## GENERAL APPLICATION

Location Address: 2200 MADISON STREET

**SUBJECT:** Site Plan review for a 12 unit residential development (Madison Apartments).

12 Unit Apartments  
2200 Madison St.  
Hollywood, FL 33020  
FLORIDA  
BROWARD COUNTY

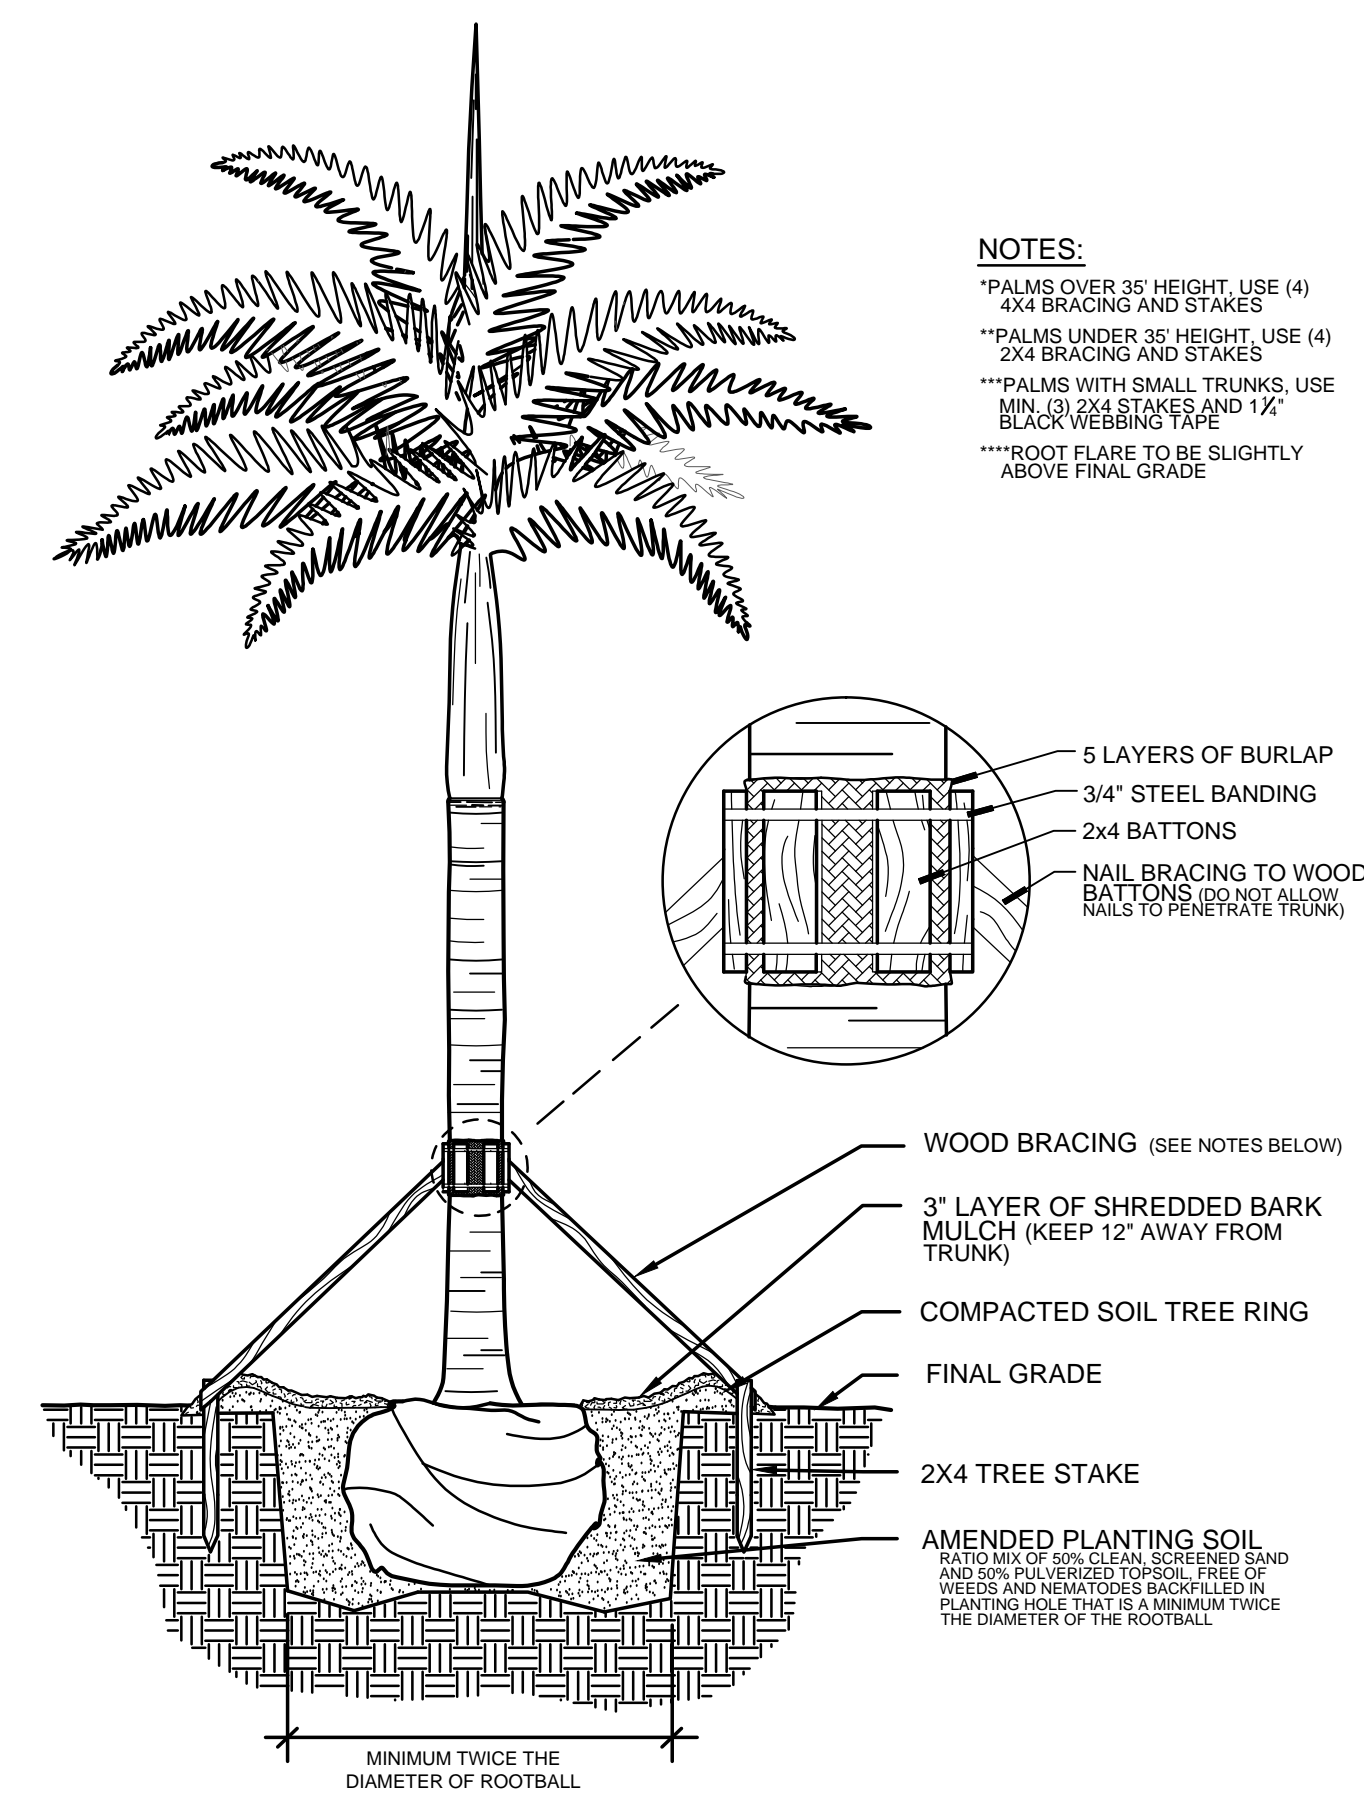
1. Provide a detailed landscape plan by a Landscape Architect that complies with all the requirements according to City of Hollywood Landscape manual, chapter 155.52, Article 9 LDR and section 6 landscape Plan details and specifications for technical review process. Landscape plan set to include and clarify what is been provided as per city code requirements for landscape for project zone type and any trees of compensation or mitigation if any trees are to be removed.

1. Provide information for existing trees on site including location, species, estimated ht./spread, and caliper diameter of trunks

2. Provide a detailed tree disposition plan in separate (if any trees to be removed) and landscape plan by a registered professional licensed Landscape Architect in the State of Florida that compliments the building architecture and uses, provides for shade, beautifies the site, accentuates site features, and serves as a buffer where appropriate. Provide tabular data chart on plan that identifies City of Hollywood landscape requirements and how they are being met for Perimeter landscape, Interior landscape for at grade parking lots and vehicular use areas, open space, view triangle, planning and development board and historic preservation board and irrigation.

## IRRIGATION PLAN

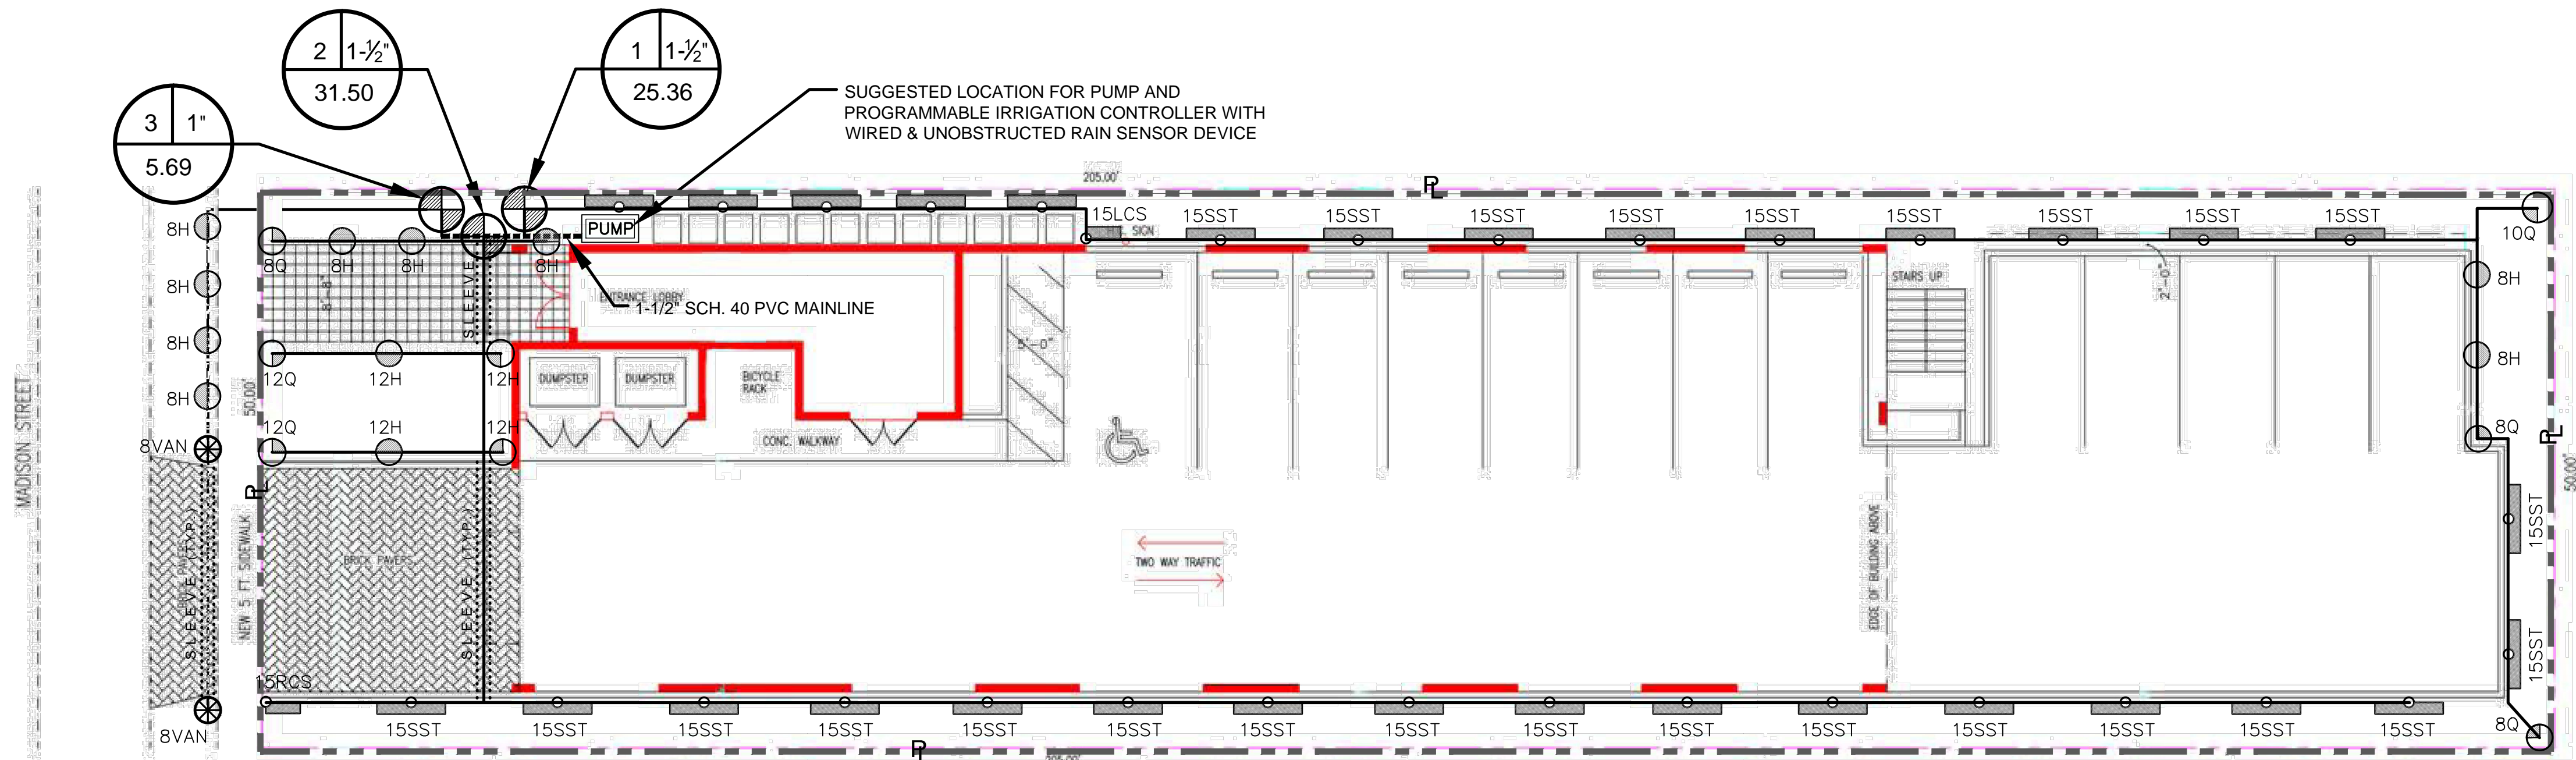
3. Provide irrigation plans for an automatic underground irrigation system for the project. Irrigation plans shall be prepared, signed and sealed by a registered professional licensed to do such design under State of Florida Statute 481.303(6)(c) or as otherwise prescribed under Florida Statutes.

CIVIL PLAN  
SCALE: 1:10

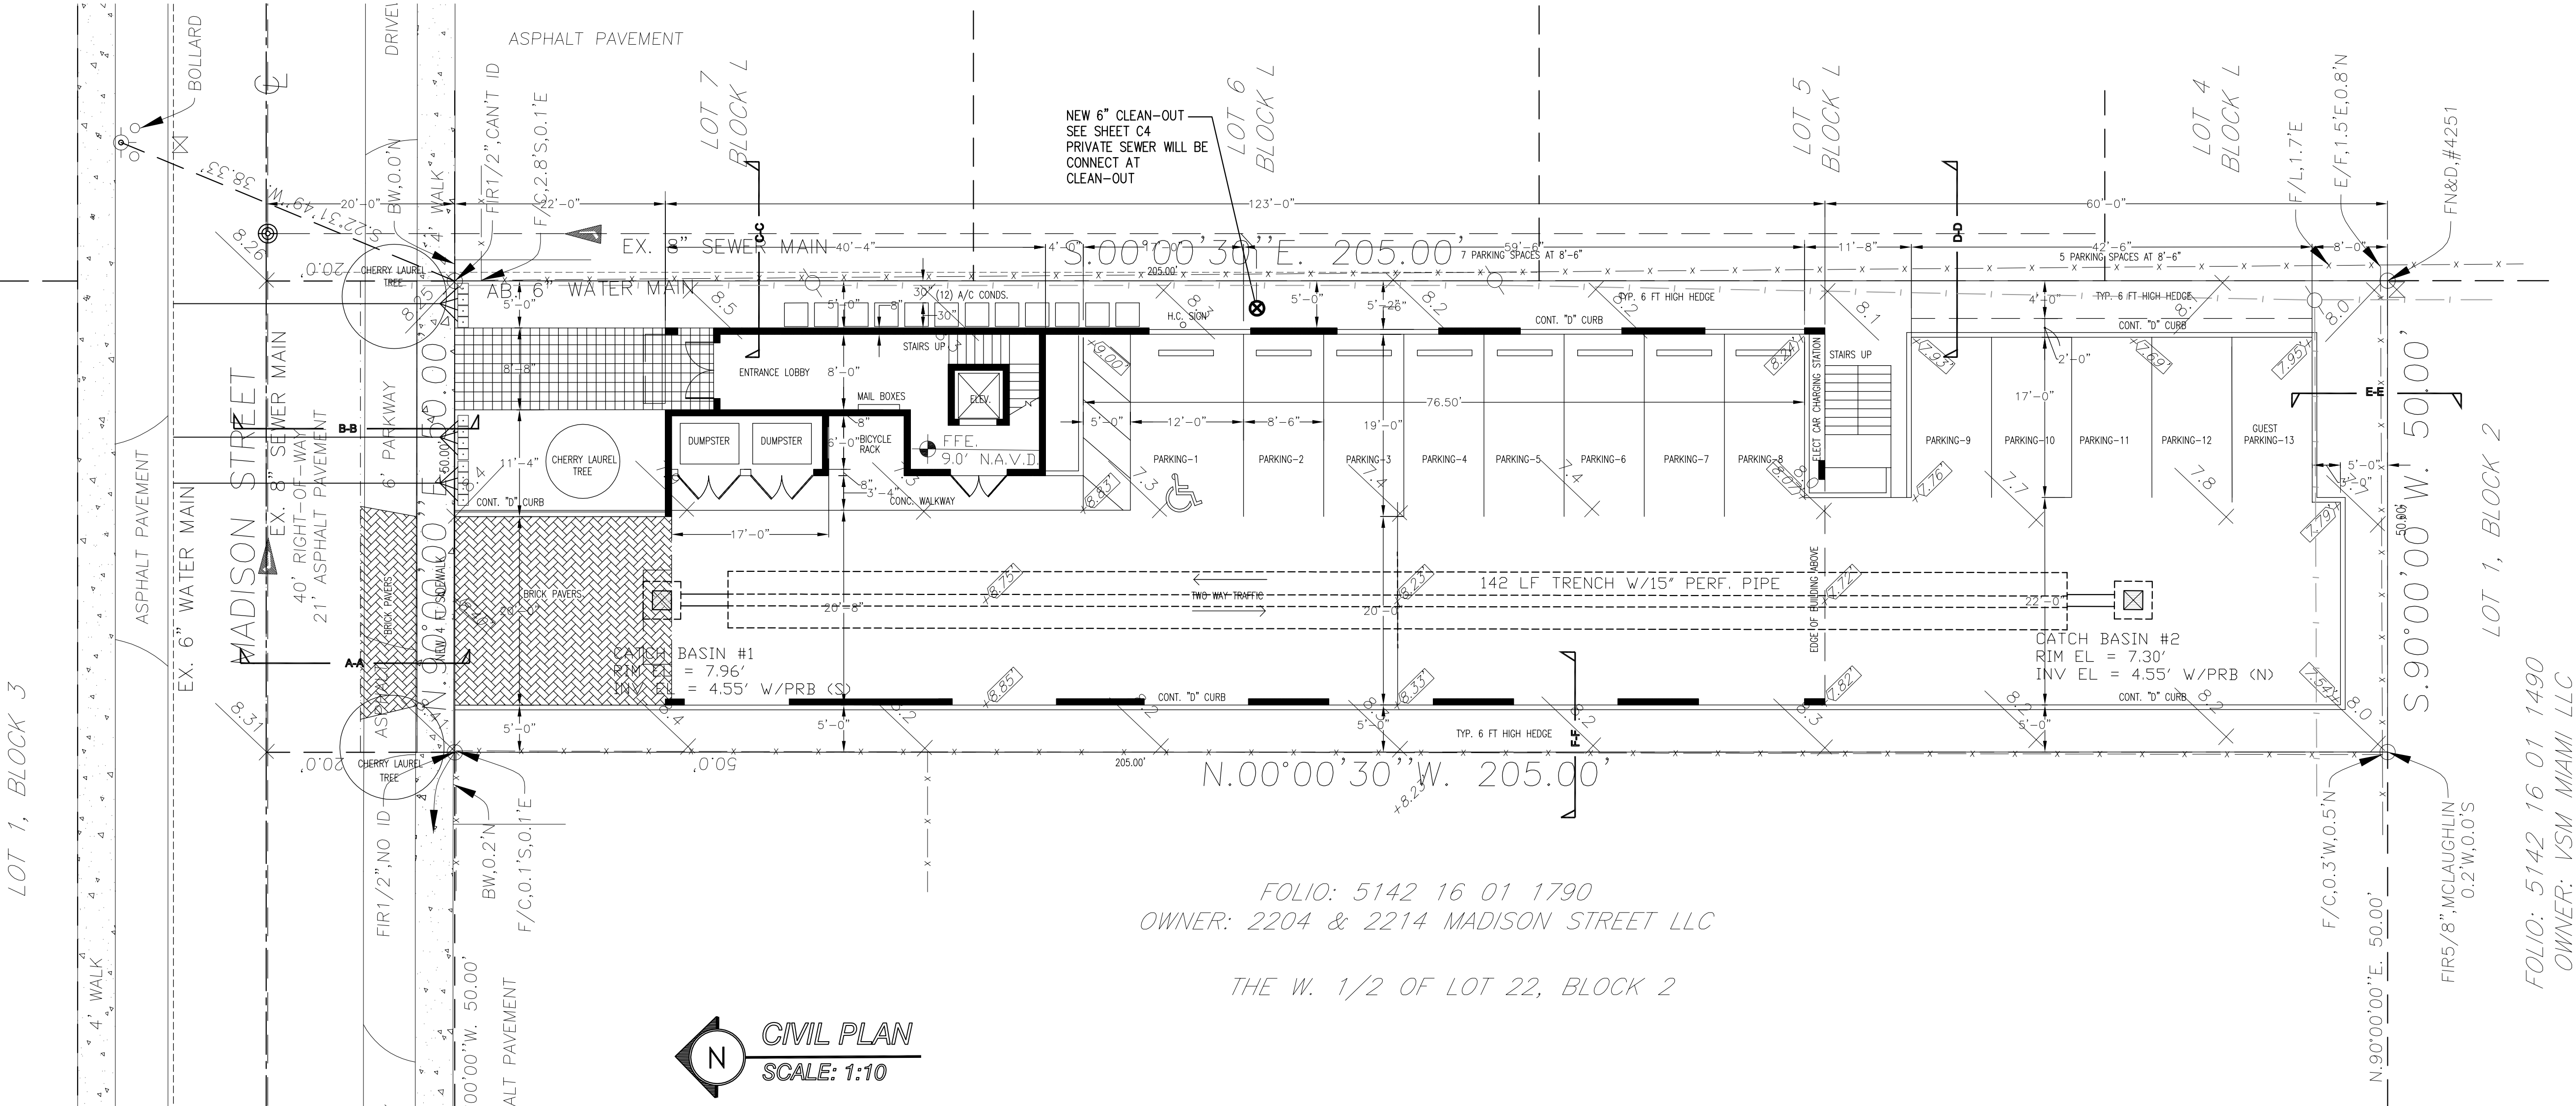
1. Driveway and drive aisle minimum width is 22 feet for two-way traffic.
2. Provide civil plans for the proposed work. Provide and indicate items such as but not limited, curbing, all vehicle turning radii, vehicular sight triangles, pavement marking and signage plans and details. Indicate and show all change in elevations. Show any utility work within City rights-of-way for utility connection, indicate any pavement restoration. Full road width pavement restoration required, provide pavement restoration detail.
3. Indicate existing sidewalk along Madison Street to be replaced on plans.
4. All outside agency permits must be obtained prior to issuance of building permit.
5. Park impact fees will be required prior to issuance of Building Permit.
6. More comments may follow upon review of the requested information.

1. Provide water and sewer demand calculations on water and sewer plans.
2. Contractor to verify condition and size of water service and sewer lateral prior to connection.
3. Provide civil plans indicating location and size of proposed water and sewer connections to existing 8-inch water main and 8-inch sanitary sewer line.
4. Provide civil plans showing existing elevations as shown on survey.
5. Provide swales and cross sections for each property side to ensure onsite retention of stormwater runoff.
6. Indicate how roof drainage will be collected and retained onsite.
7. Provide pre vs post development drainage calculations.

8. Finished floor elevations (FFE) and equipment shall be at a minimum elevation of 10' NAVD88 minimum per FEMA FIRM Zone AH, with BFE at 9-feet NAVD 88.
9. Landscape architect should coordinate with civil plans to accommodate for drainage swales and retention areas accordingly.
